THE RECTORY

DHDC SET
4/24/2023

IANNUZZI

TABLE OF CONTENTS

SHEET NUMBER:
A2.0
SHEET TITLE:
PROP. EXTERIOR ELEVATIONS
© Iannuzzi Studio PLLC 2019

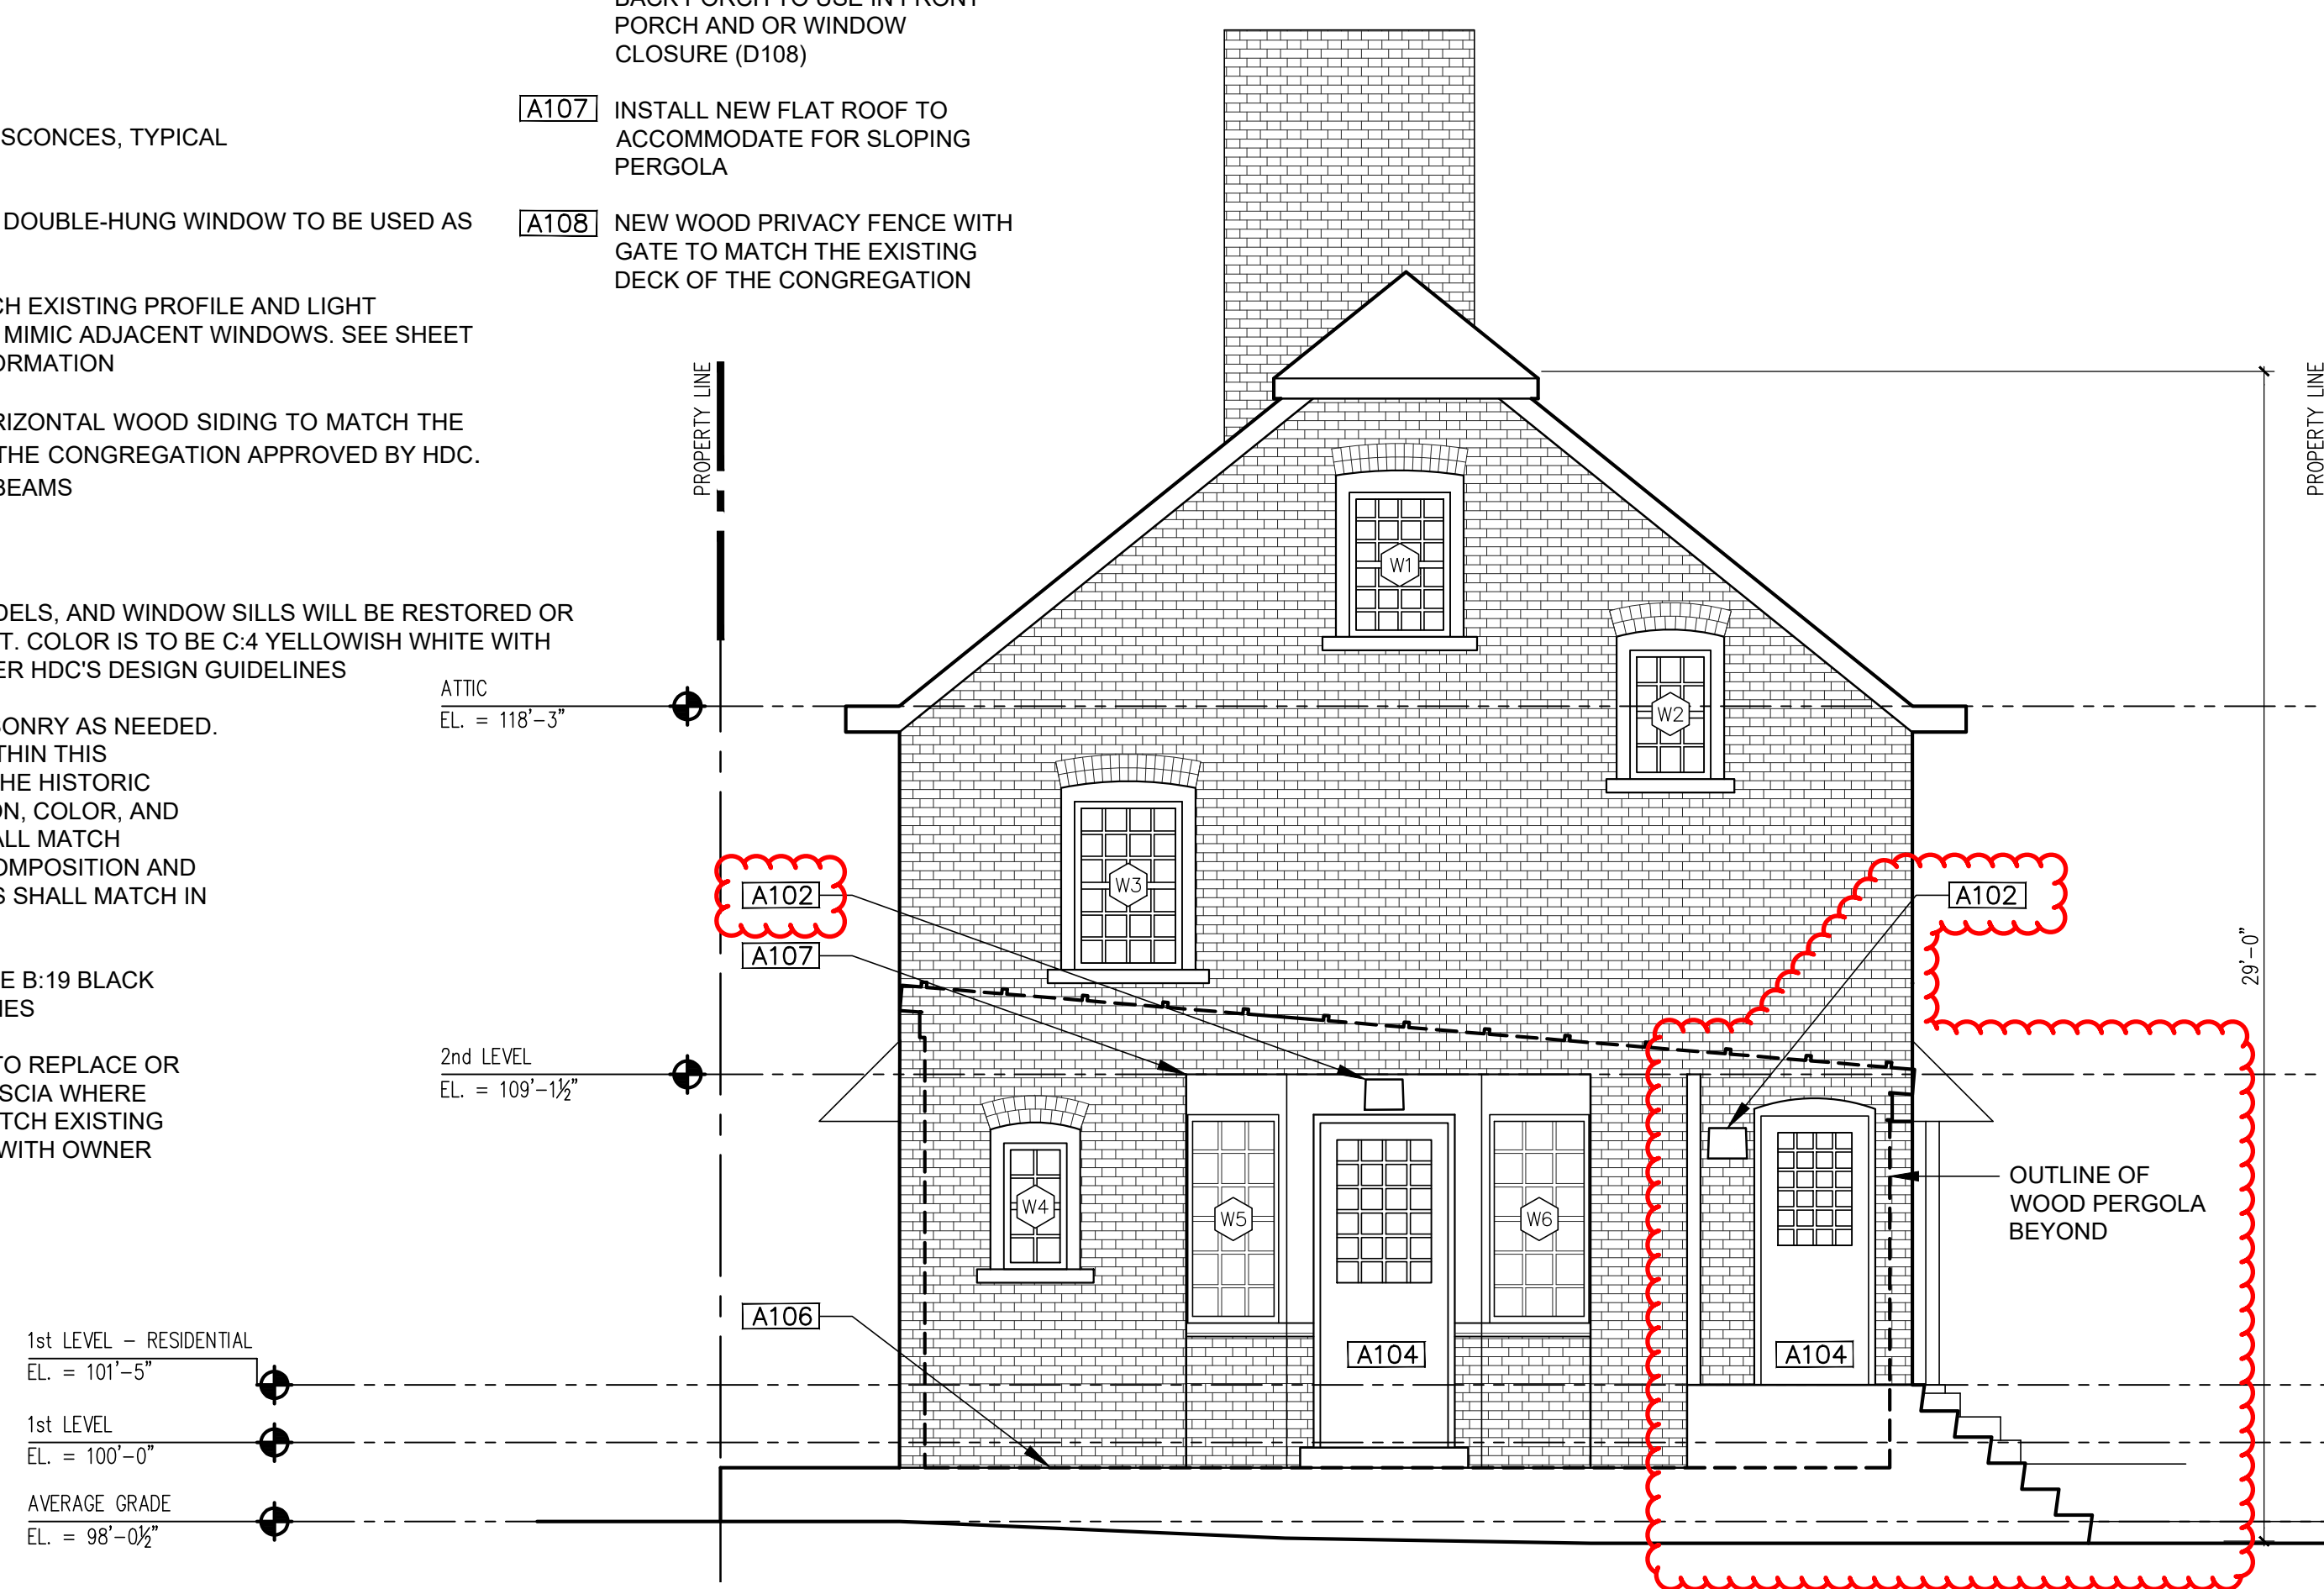
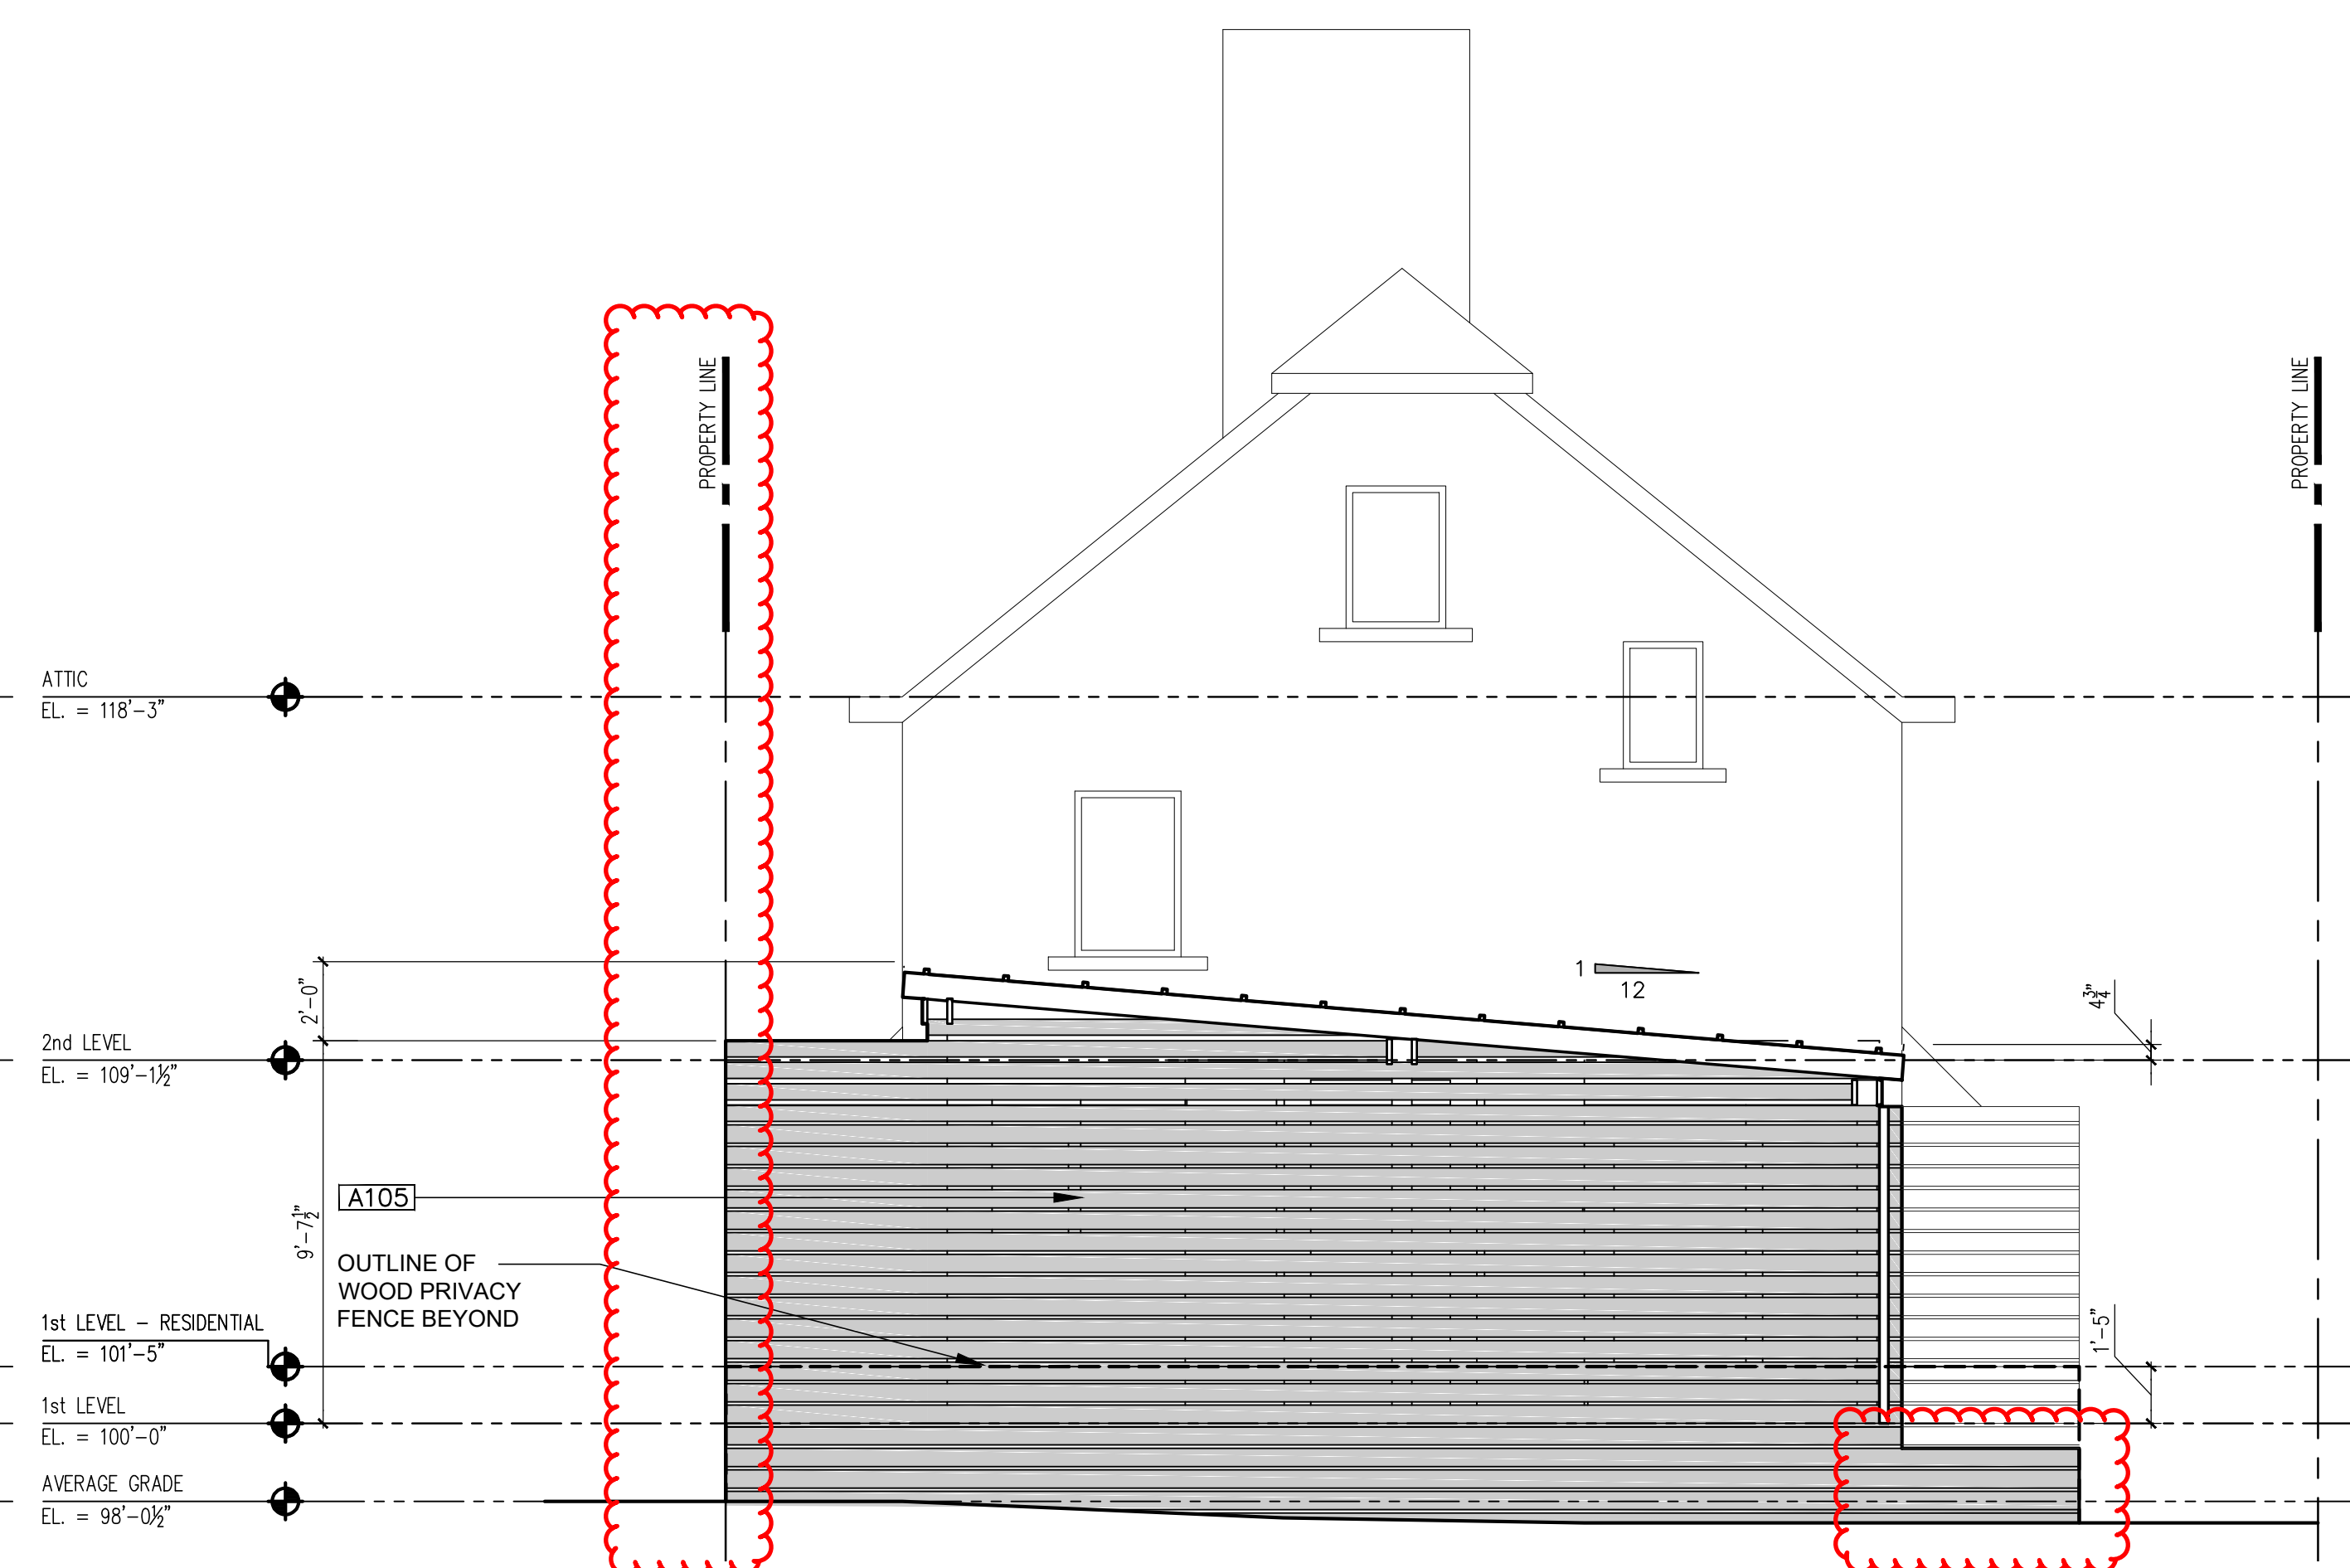
A109 EXHAUST FAN

A110 PROPOSED ADA WOOD RAMP BUILT OF 4x POSTS FINISHED WITH A WOOD CAP. GUARDRAIL PLACED BETWEEN POSTS AT 36" HEIGHT ALONG RAMP AND WOOD RAILING MOUNTED ONTO POSTS AT 34" HEIGHT ALONG RAMP. MAXIMUM SLOPE OF RAMPS TO BE 1:12.

NORTH ELEVATION

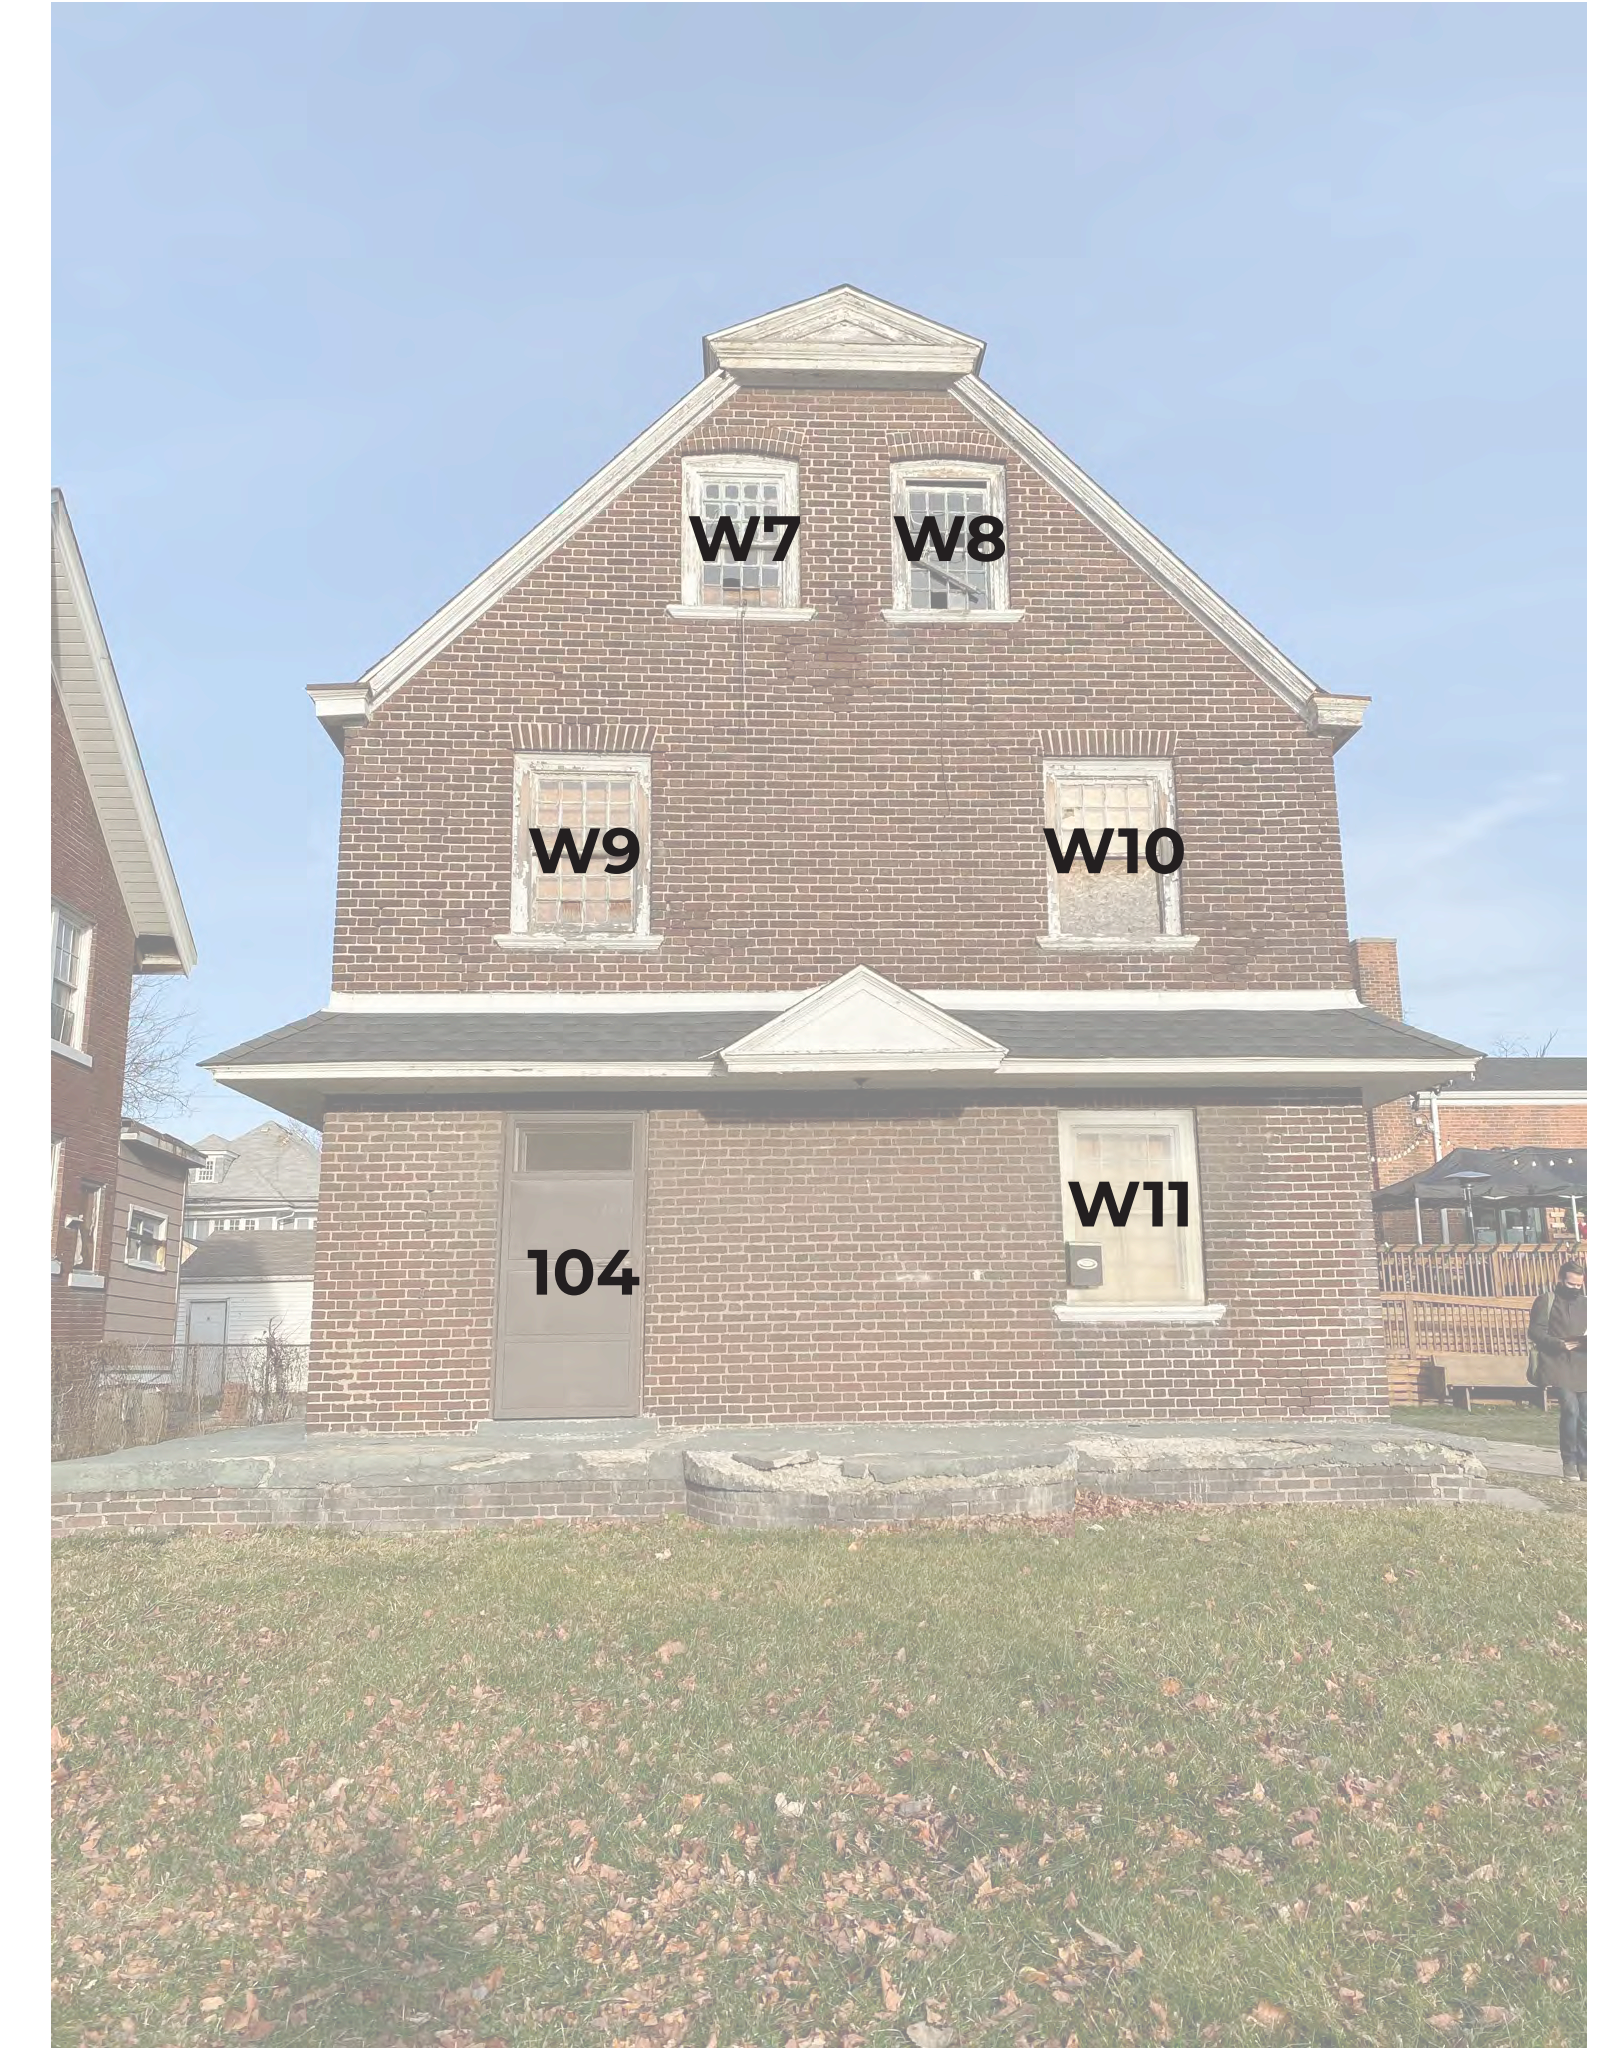
REMOVING WINDOW TO
MOVE DOOR 103 UP FOR
NEW PATIO - SEE
ELEVATIONS AND PLANS
